**Oncor and Lower Colorado River
Authority (LCRA TSC) - Muscovy and
Voss Lake 345/138-kV Project (25RPG009)
– ERCOT Independent Review (EIR)
Status Update**

Regional Planning Group (RPG) Meeting
April 13, 2026

This project is currently under ERCOT independent Review (EIR)

Option 4 – Alternative Oncor Option

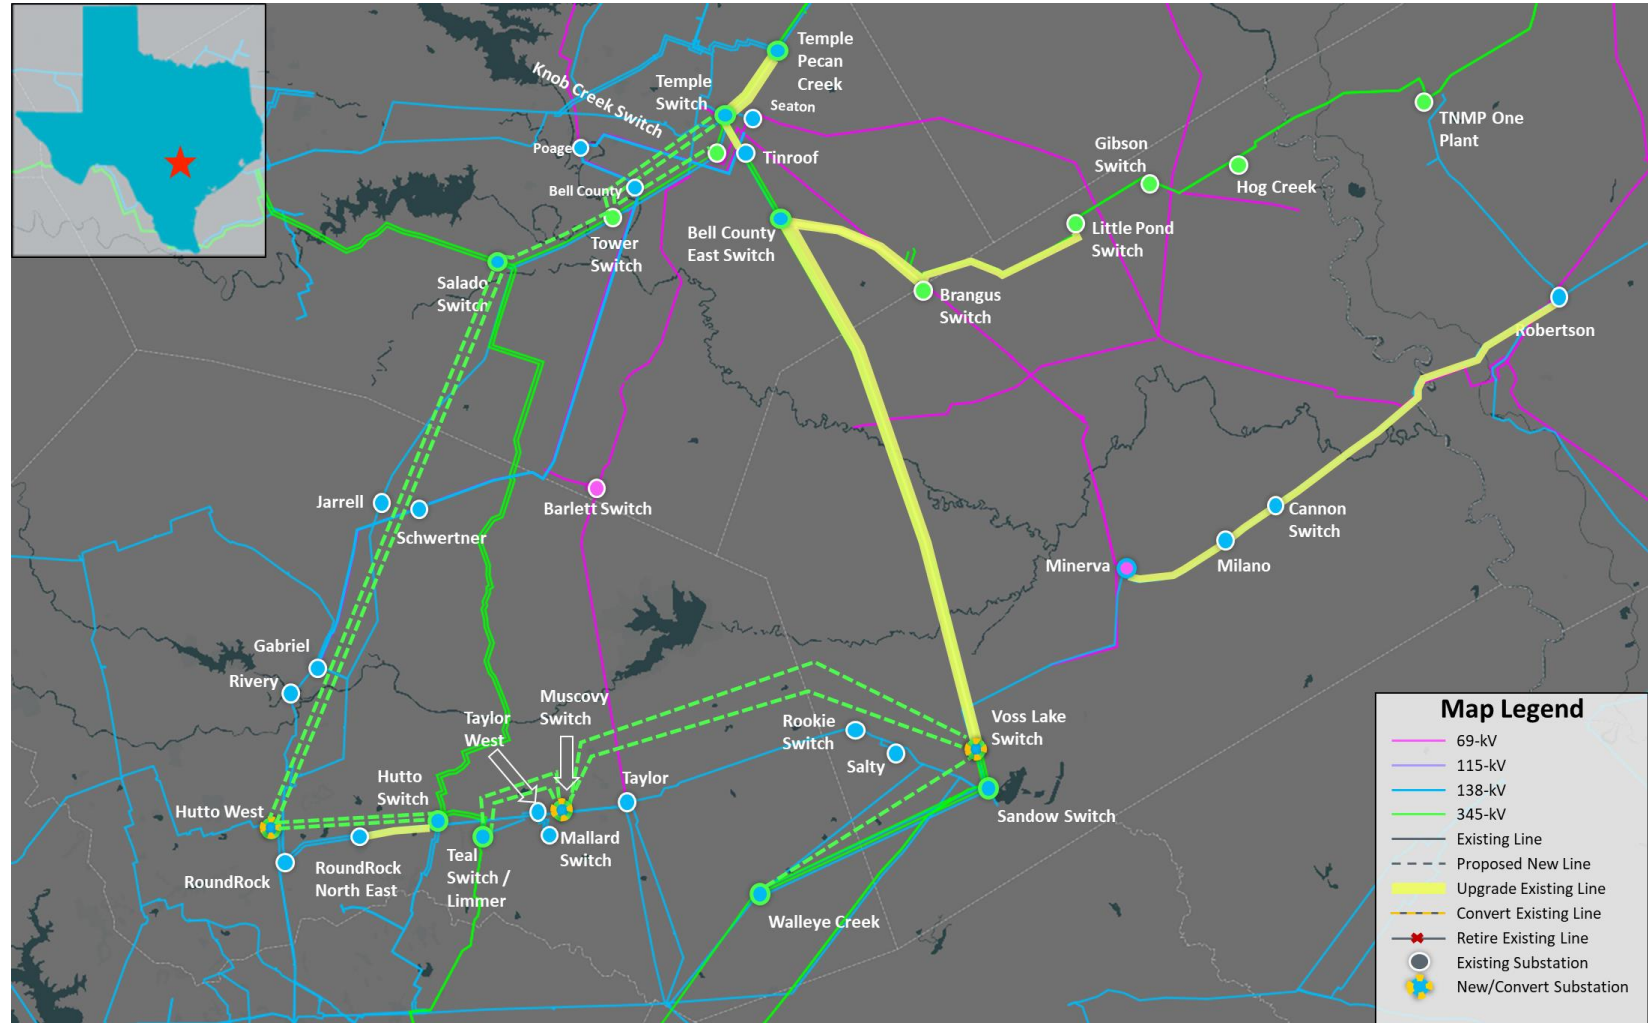
- Option 3 Upgrades except for Salado to Hutto Switch 345-kV double circuit line
- Establish new Hutto West 345-kV Switch
- Install two new 345/138-kV auto transformers
- Build new Salado Switch to Hutto West double circuit 345-kV line
- Build new Hutto West to Hutto Switch double circuit 345-kV line

Option 4A – Alternative Oncor Option plus additional 138-kV upgrades – Hutto West Zoomed-in

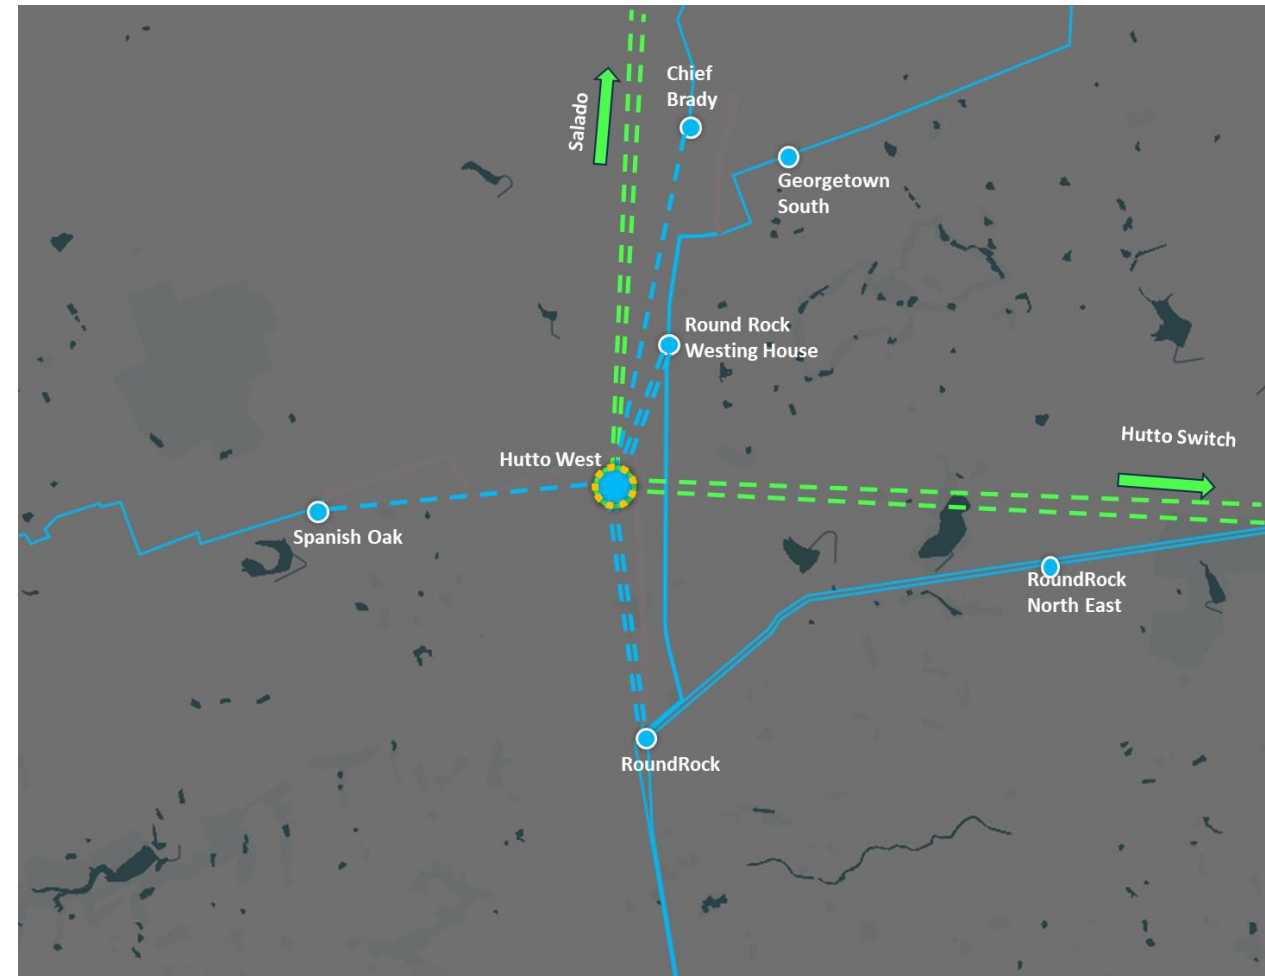
- Option 4 Upgrades
- Loop Spanish Oak to RoundRock 138-kV line into Hutto West
- Loop Chief Brady to RoundRock 138-Kv line into Hutto West

Option 5 – Alternative ERCOT Option

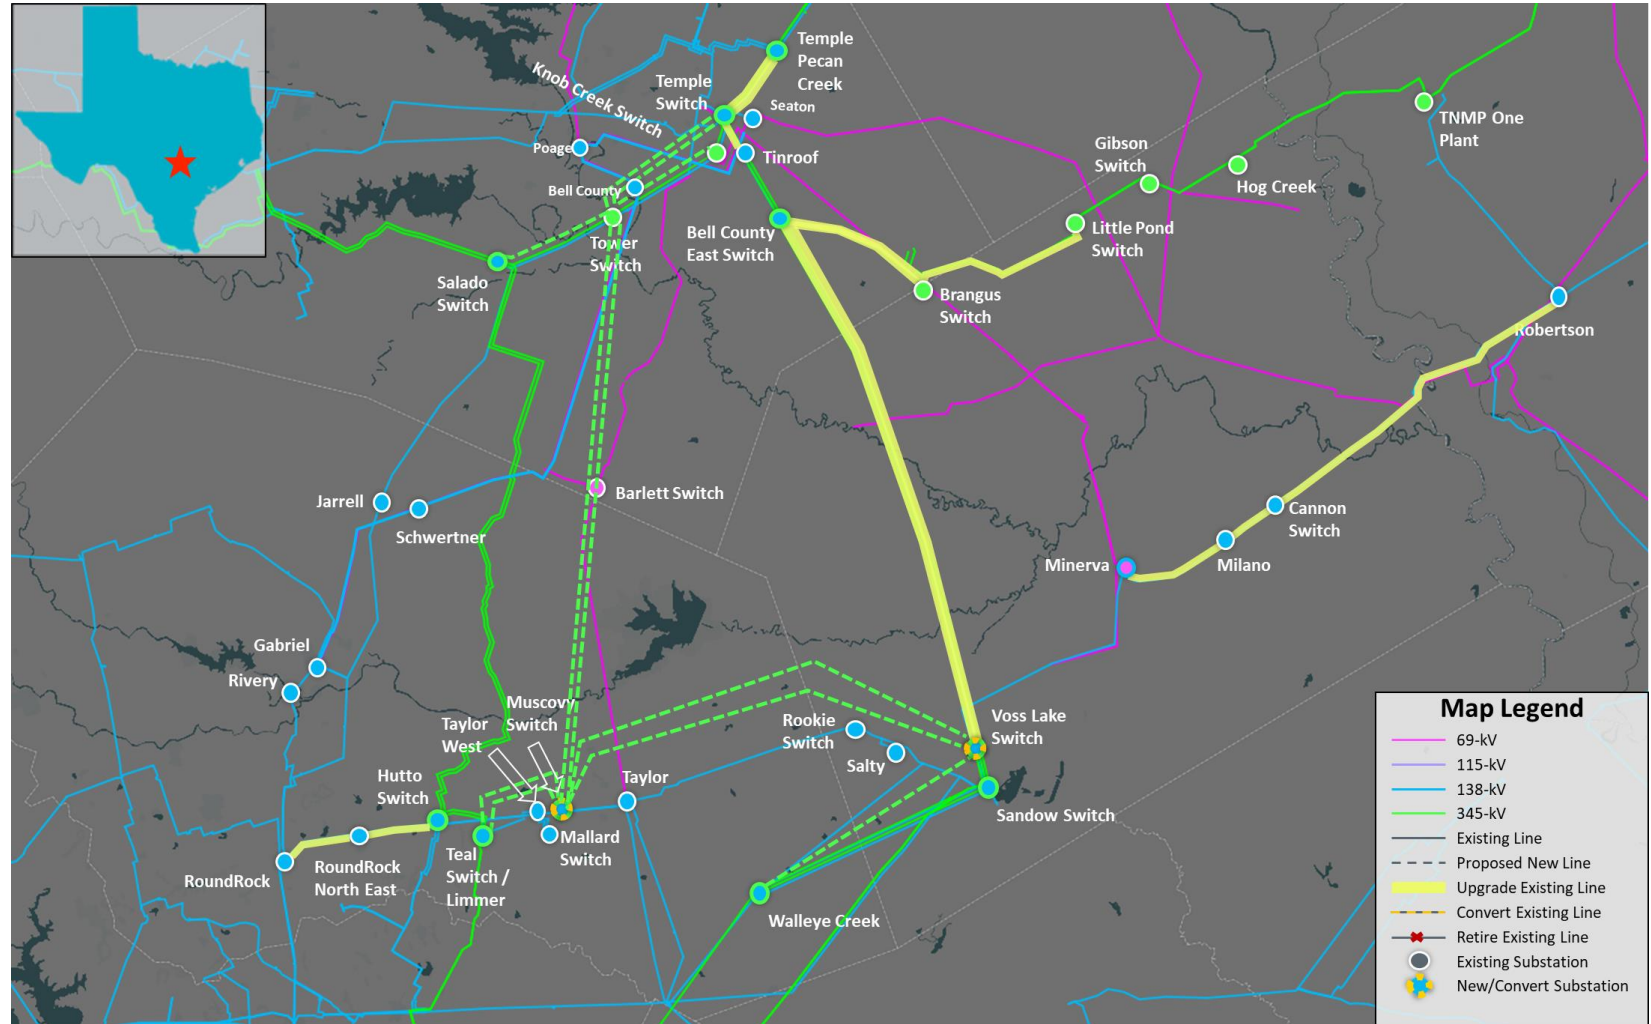
- Option 3 Upgrades except for Salado to Hutto Switch 345-kV double circuit line
- Build Muscovy to Limmer double circuit 345-kV lines on separate structures
- Build new 345-kV double circuit lines from Tower Switch to Muscovy Switch.
- Upgrade RoundRock North East to RoundRock 138-kV line

Option 6 – Brazos Suggested Option

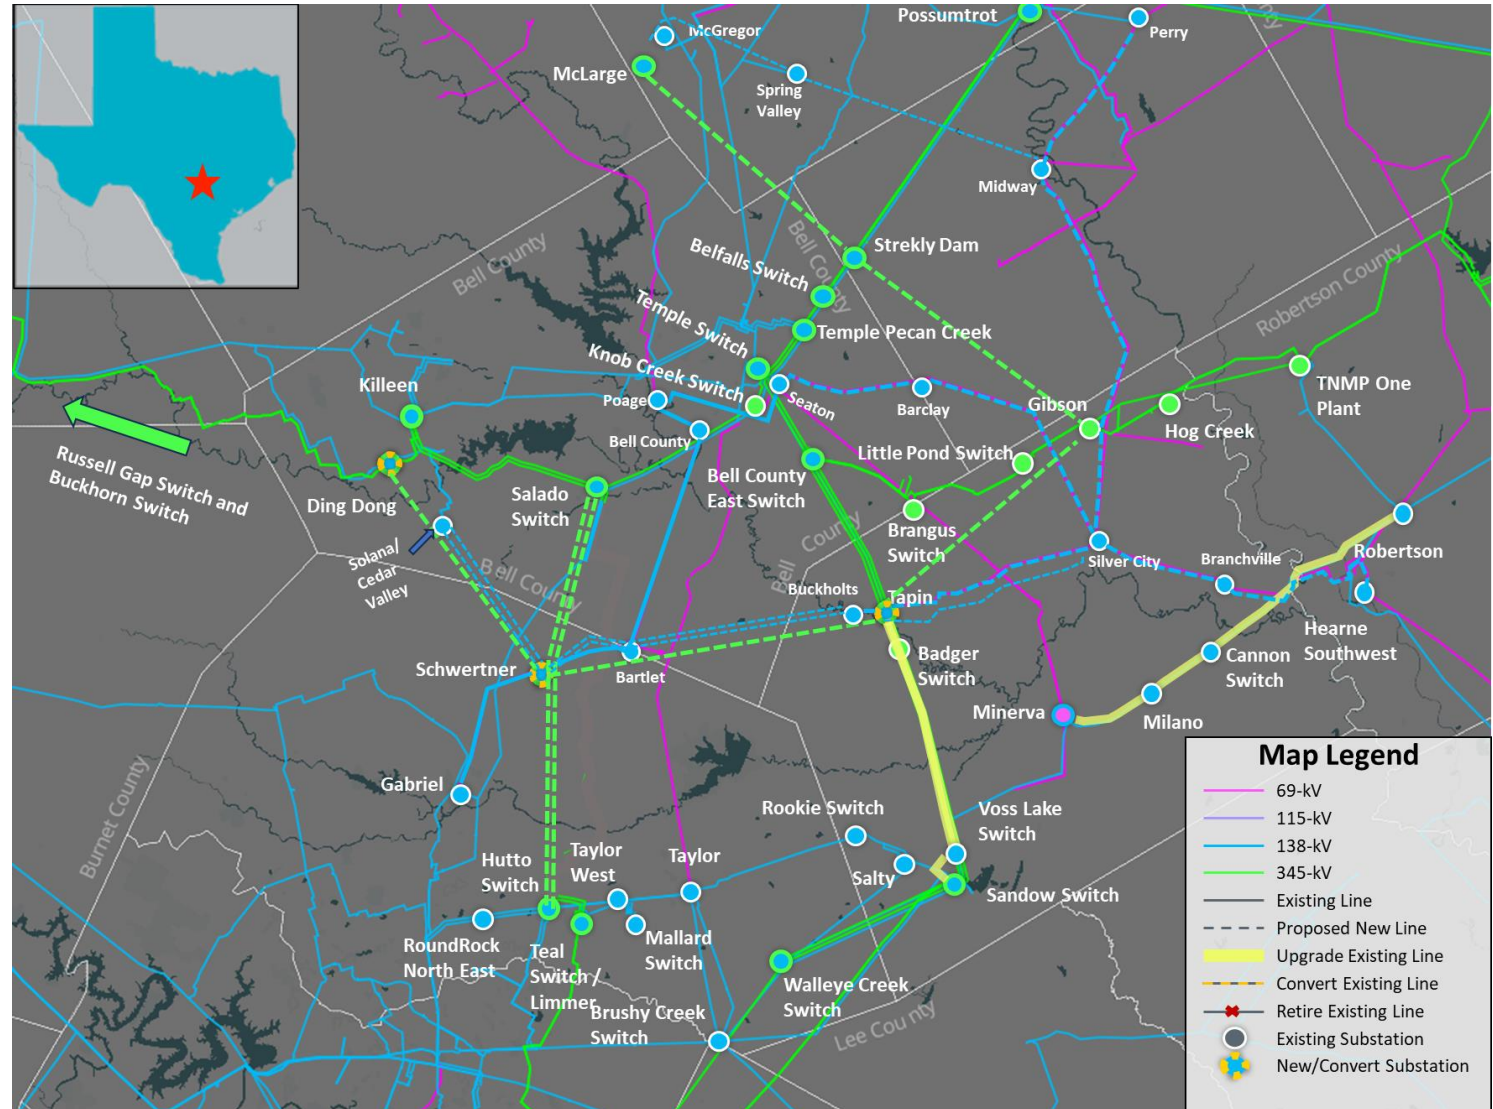
- Establish a 345-kV and 138-kV Loop Around the Temple Switch
- Establish new Dindong, Schwertner, Taping and Mclarge 345-kV Stations
- Build a new 345-kV Single circuit from Dingdong to Schwertner to Taping to Gibson to Strekly Dam to Mclarge stations
- Additional new 138-kV transmission lines
- Additional rebuilds of existing 138-kV transmission lines
